CONNECTICUT YANKEE ATOMIC POWER COMPANY

HADDAM NECK PLANT

Subject: Biennial Update to the Haddam Neck Plant License Termination Plan

Attachment 1 – Summary of Proposed Changes to the Haddam Neck Plant License Termination Plan Made in Revisions 8 and 9

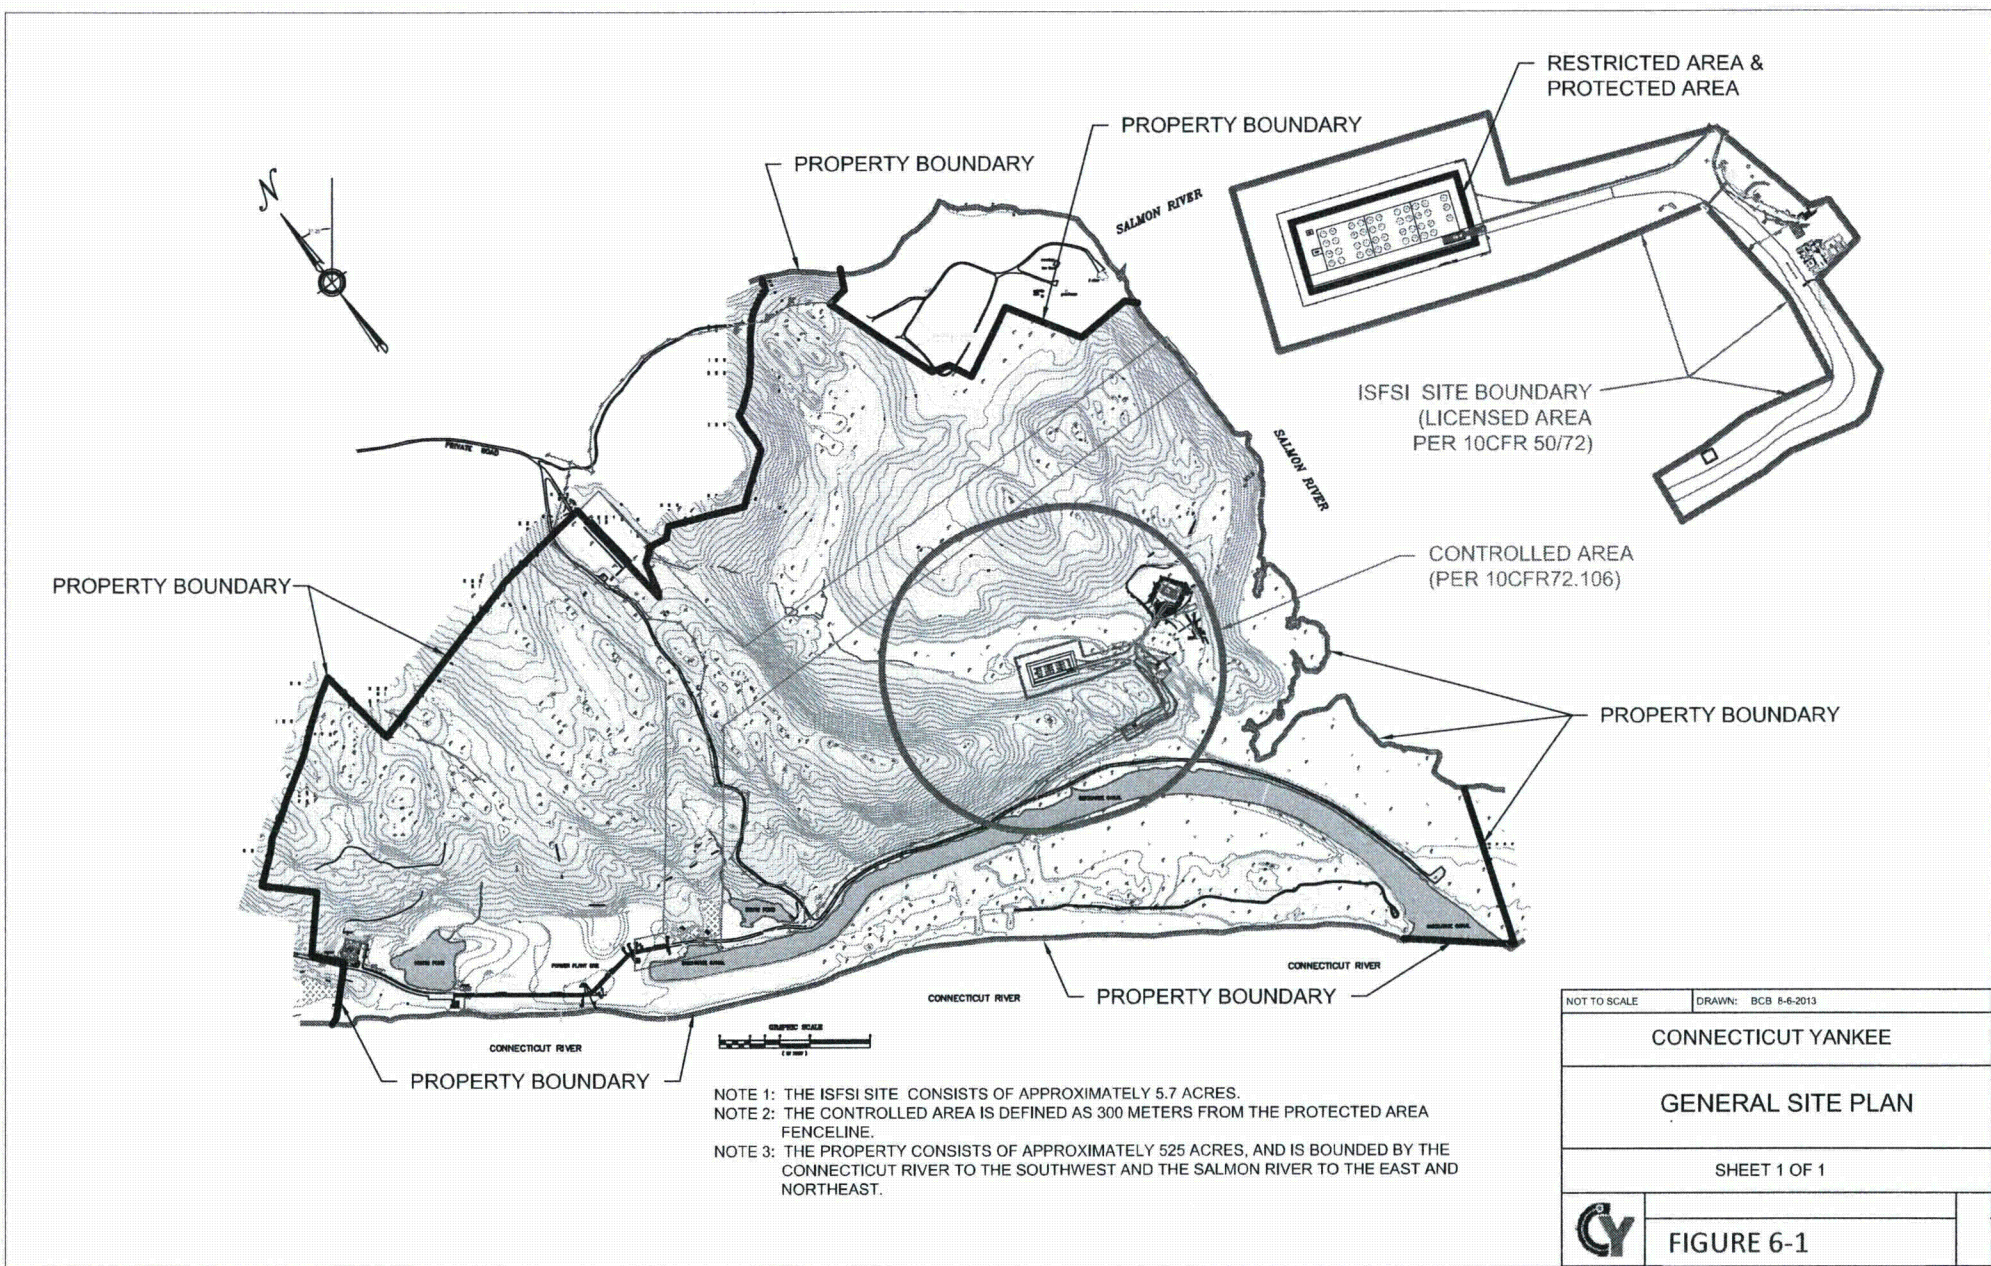
Revision 9	1.1	Reference to Figure 1-1 is changed to 6-1.	Figure 1-1 was deleted in a previous revision; thus, the current reference is incorrect. The information referenced in the text is now provided in Figure 6-1.
